## HISTORIC AND DESIGN REVIEW COMMISSION

April 02, 2025

**HDRC CASE NO:** 2025-070  
**ADDRESS:** 1024 BURNET ST  
**LEGAL DESCRIPTION:** NCB 1660 BLK H LOT E 16.2 FT OF N 120 FT OF 6 & W 39 FT OF N 120 FT OF 7  
**ZONING:** R-6, H  
**CITY COUNCIL DIST.:** 2  
**DISTRICT:** Dignowity Hill Historic District  
**APPLICANT:** Richard Gonzalez  
**OWNER:** Richard Gonzalez/NEXUS SERIES B LLC  
**TYPE OF WORK:** Construction of a rear addition, exterior and fenestration modifications, repair and maintenance, window replacement  
**APPLICATION RECEIVED:** March 14, 2025  
**60-DAY REVIEW:** May 13, 2025  
**CASE MANAGER:** Edward Hall  
**REQUEST:**

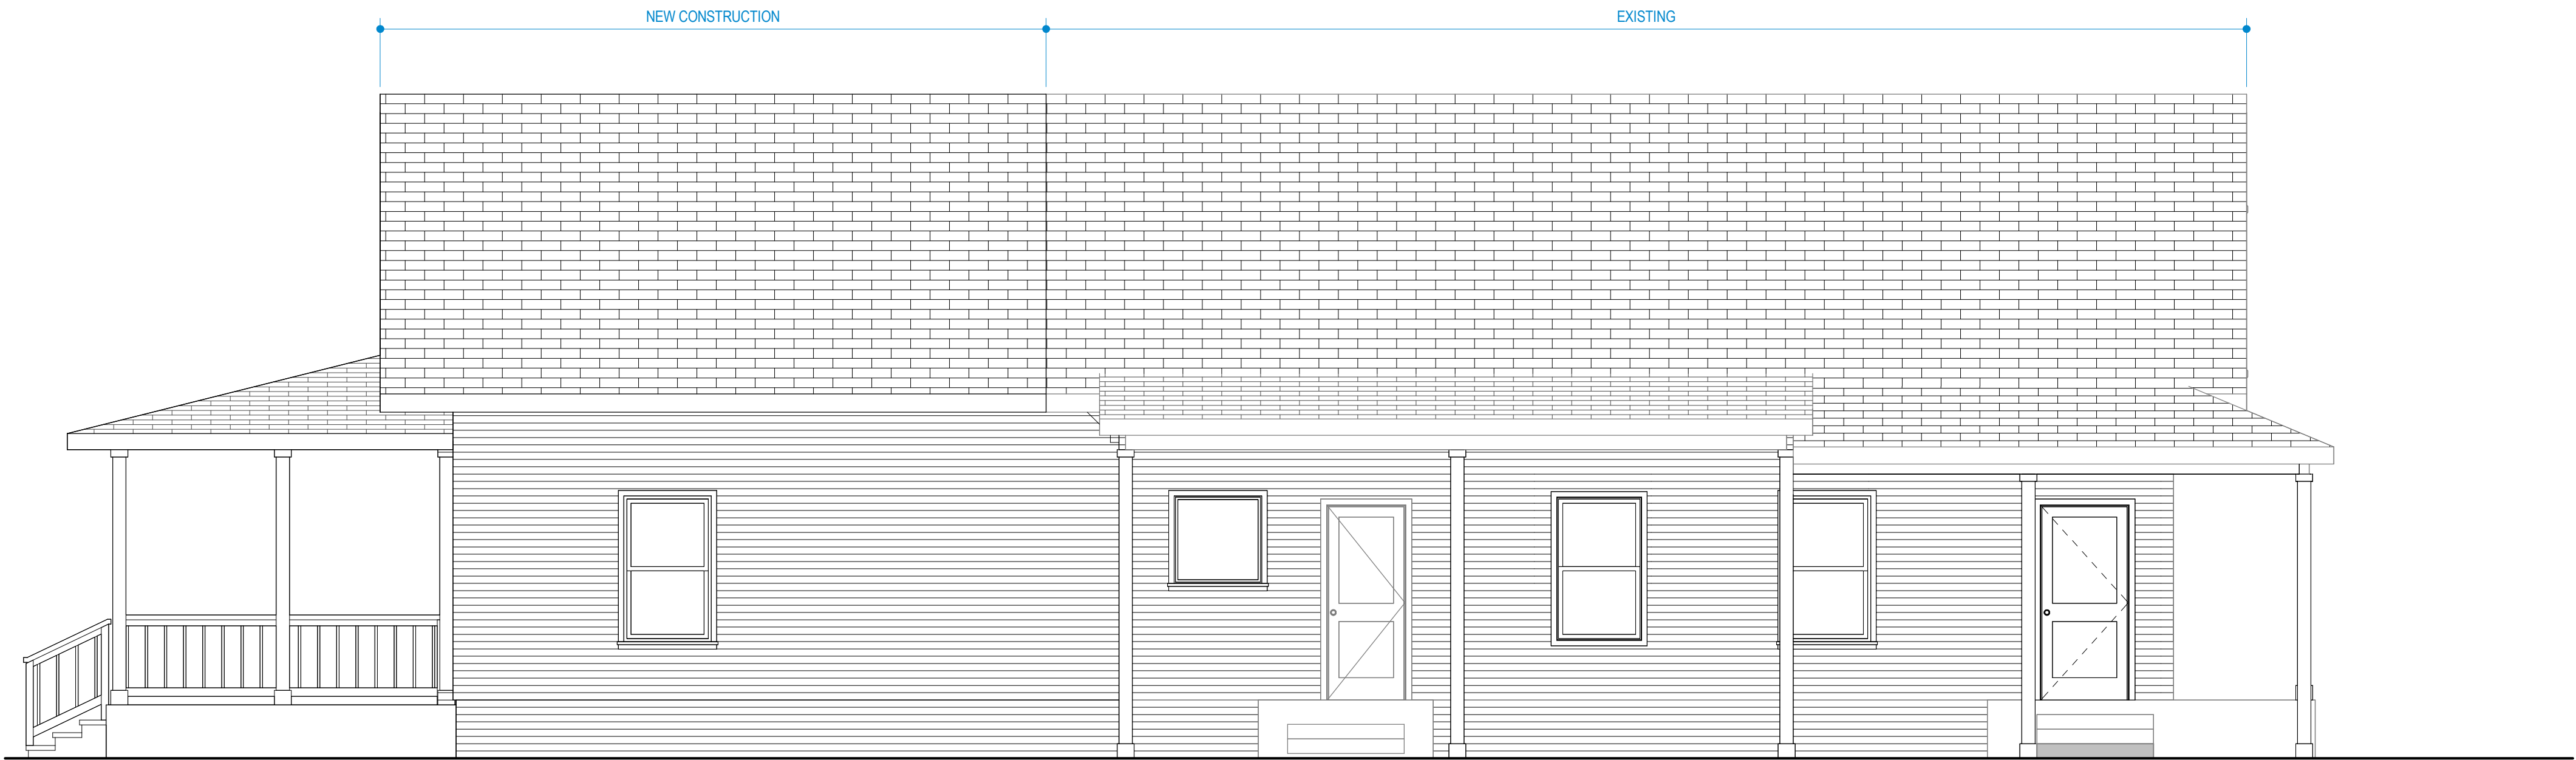
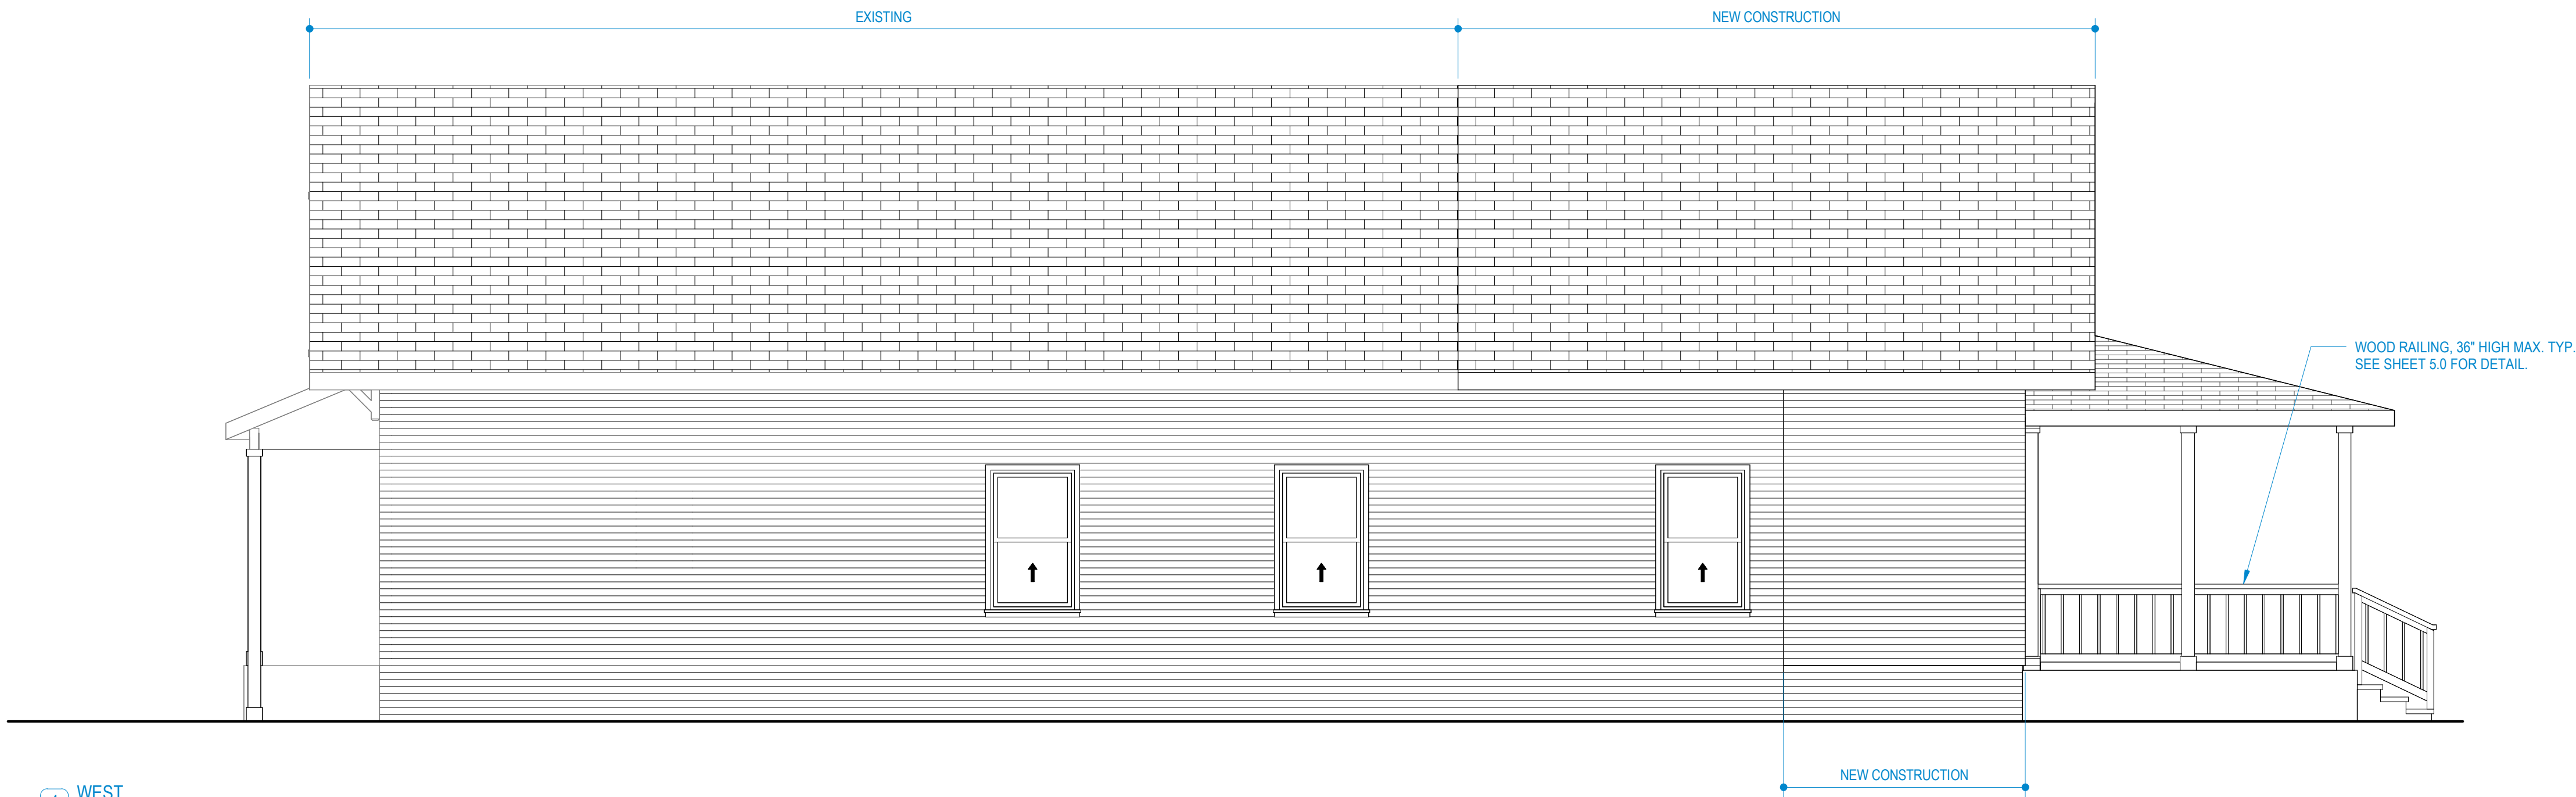
- h. REAR ADDITION (Materials) – The applicant has proposed materials that include 117 profile wood siding, an asphalt shingle roof, and wood columns and railings at the rear porch. Generally, staff finds the proposed materials to be appropriate; however, staff finds that the proposed windows should adhere to the adopted standards for windows in additions, that columns should feature six (6) inches square with capital and base trim and chamfered corners.

- i. REAR ADDITION (Architectural Details) – The rear of the historic structure currently features a set of ganged windows within the rear facing gable. Staff finds that these windows should be reinstalled in the rear facing gable of the addition. As noted in the above findings, staff finds that a wall inset or vertical trim piece should be installed on both side facades where the addition meets the original structure.

- 4. Staff recommends approval of item #4, the construction of a rear addition based on findings f through i, with the following stipulations:
  - i. That the proposed addition feature either a setback from the original structure’s side facades or a vertical trim piece to differentiate the addition from the original structure.

- ii. That windows that adhere to the adopted standards for windows in additions be installed. Windows are to be submitted to OHP staff for review and approval prior to purchase and installation.

- iii. That all columns feature six (6) inches square with capital and base trim and chamfered corners. A revised columns details is to be submitted to OHP staff prior to the issuance of a Certificate of Appropriateness.

- iv. That the set of ganged, wood windows currently within the rear facing gable be reinstalled within the addition’s rear facing gable.

PHOTO PRIOR TO VIOLATION - ADDED FOR REFERENCE ONLY

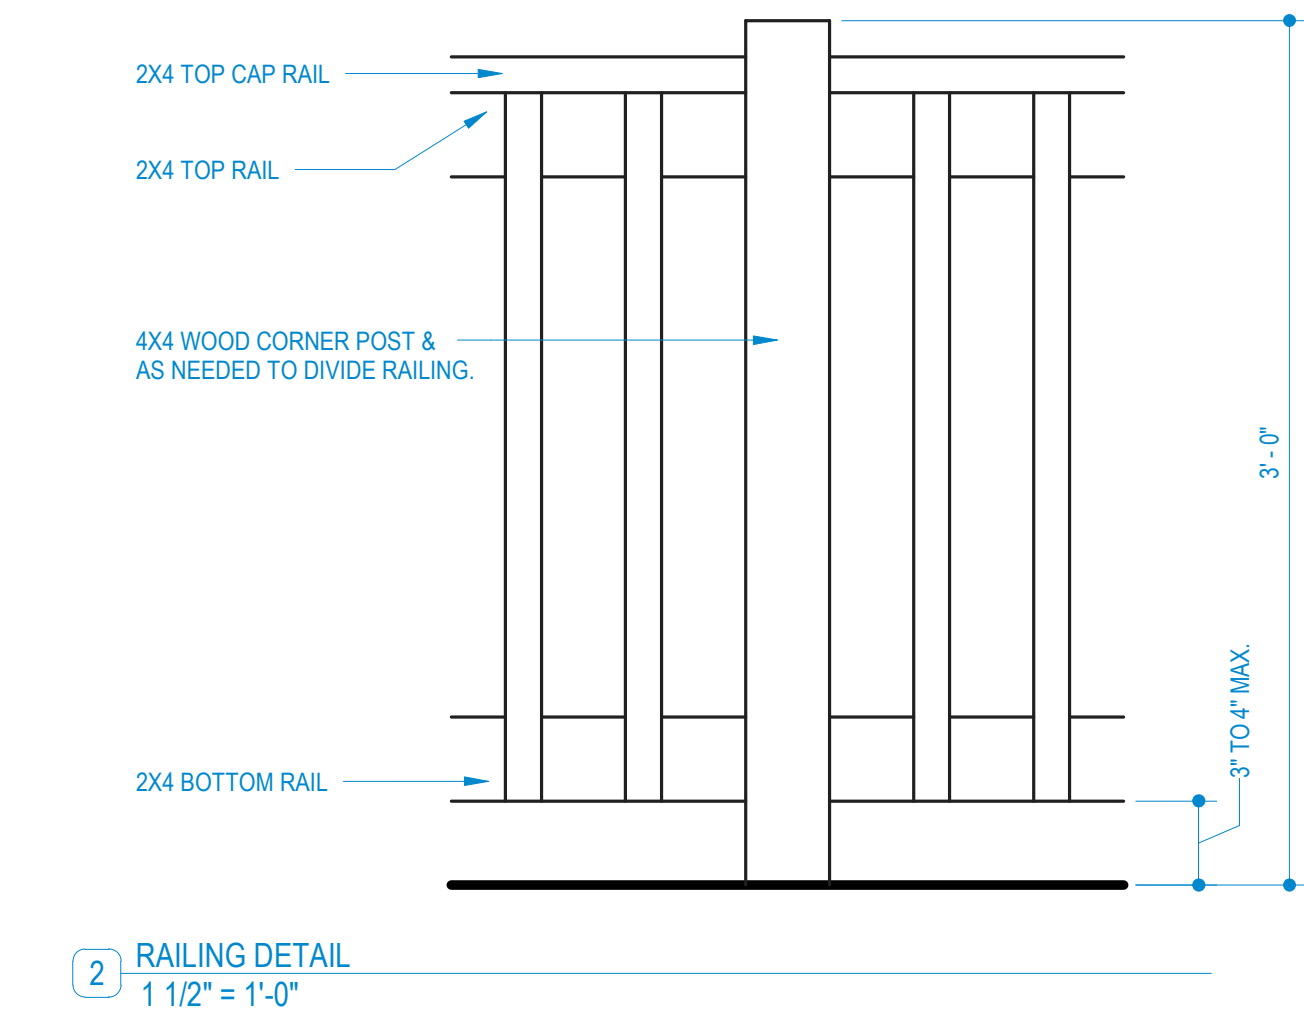
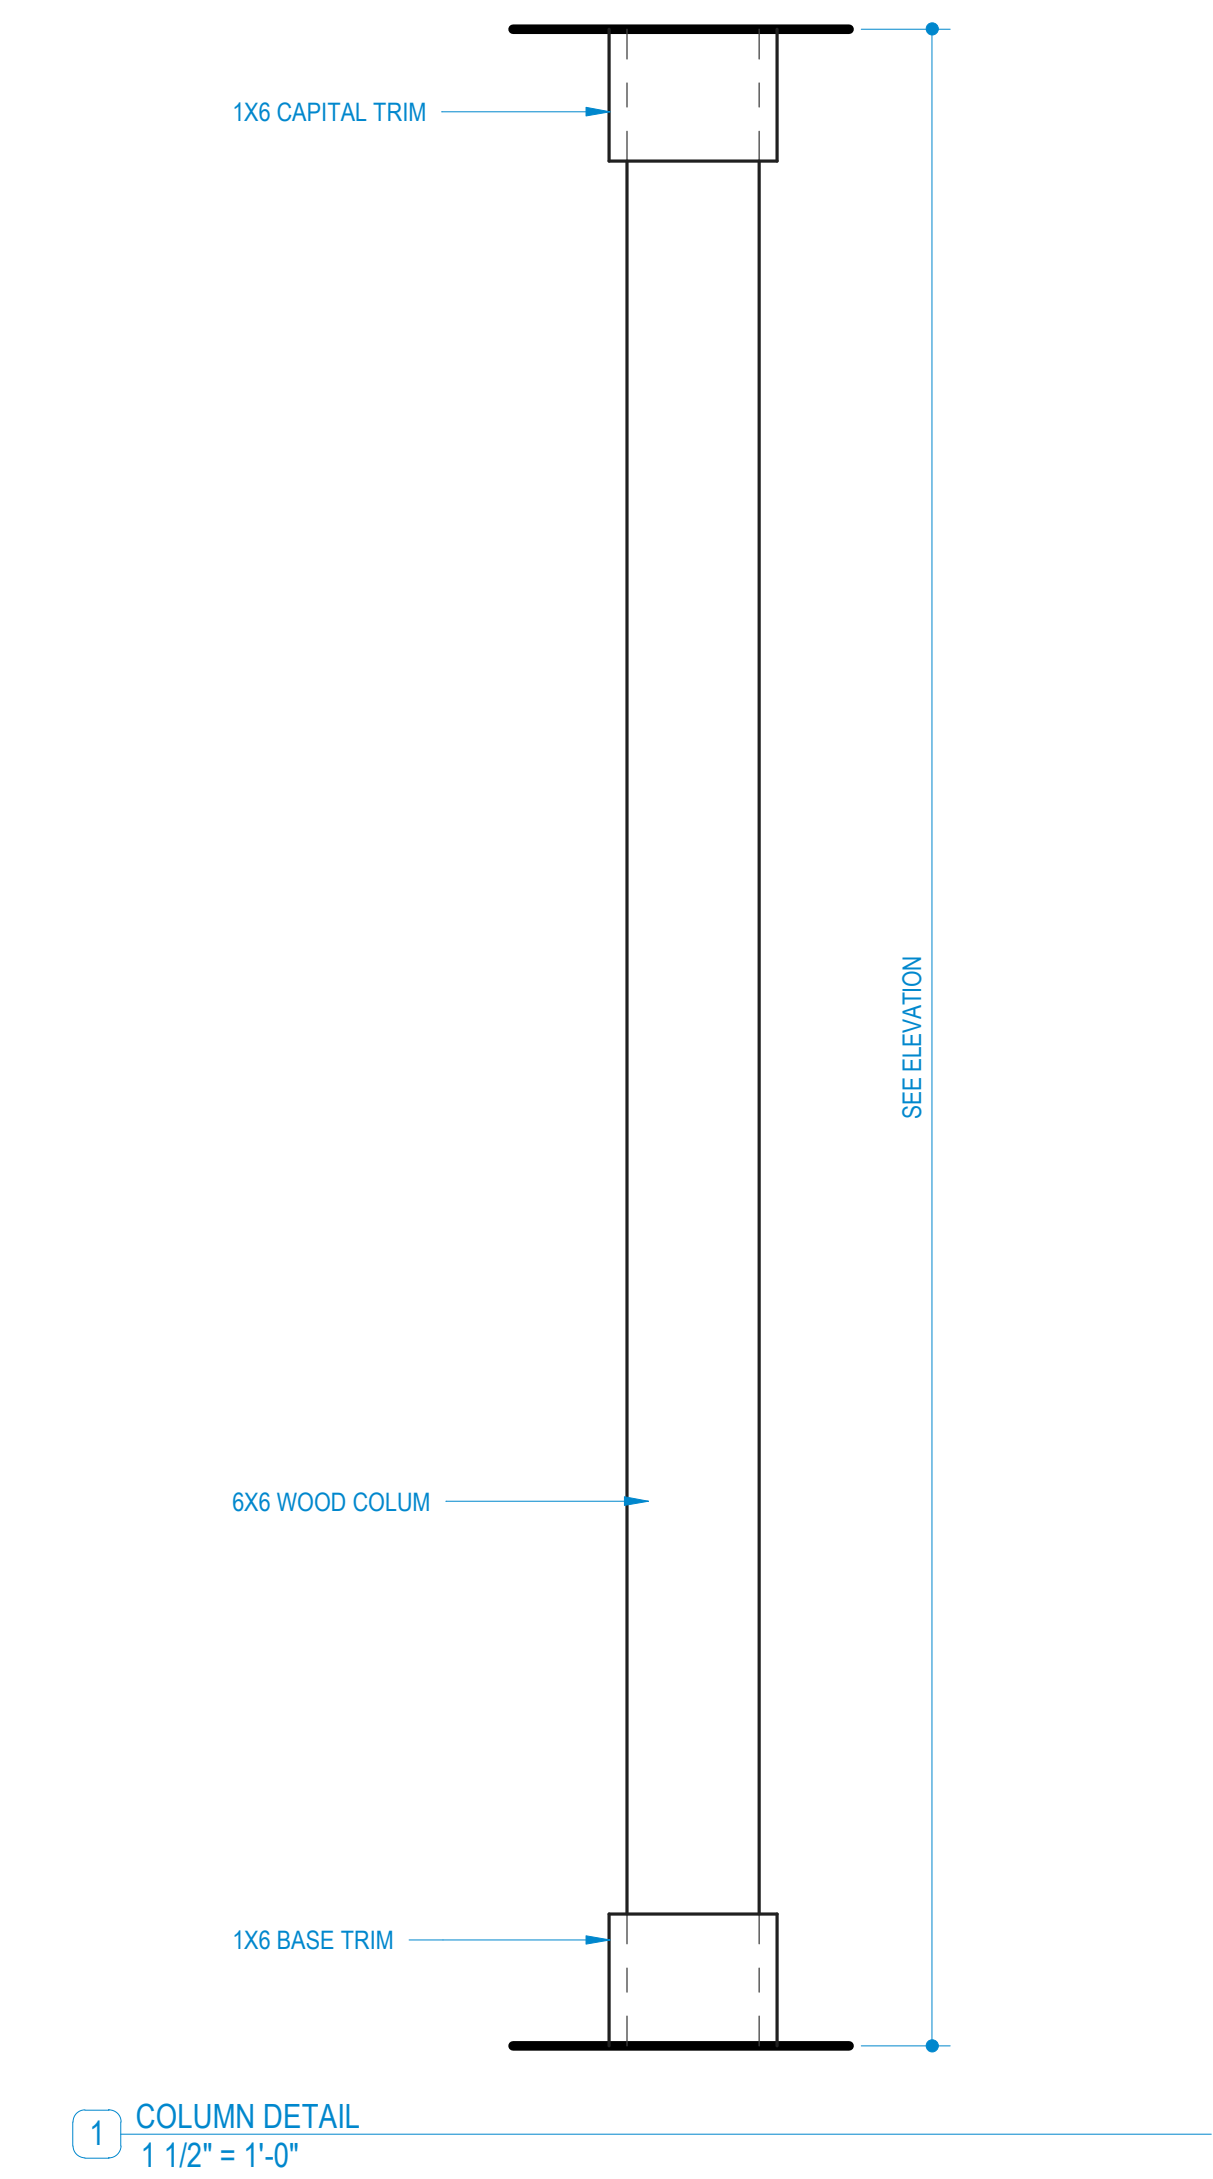
- e. **WINDOW REPLACEMENT** – The historic structure currently features a combination of windows, including one over one wood windows, one over one aluminum windows, and fixed aluminum windows. The applicant has proposed to replace all existing windows with new, one over one windows. Generally, staff finds this to be appropriate; however, staff finds that wood, one over one windows should be installed on the west façade, as wood windows most recently existing here. Wood windows on the west façade were removed without approval in December

2023, as noted in finding b. Any original window openings that have been enclosed should be reopened and feature wood, one over one windows. Replacement windows should adhere to the standards for

- ii. That all grouped windows be separated by mullion of six (6) inches to match those found historically on site.
  - iii. That wood, one over one windows be installed on the west façade where original windows were removed without approval in December 2023. This will include the reopening of enclosed window openings.

- iv. That all replacement windows abide by the adopted standards for window replacement, as noted in finding e and in the applicable citations. Windows are to be submitted to OHP staff for review and approval prior to purchase and installation. Where aluminum windows currently exist, aluminum windows may be installed, with the exception of the window openings on the west façade, previously noted in stipulation ii.
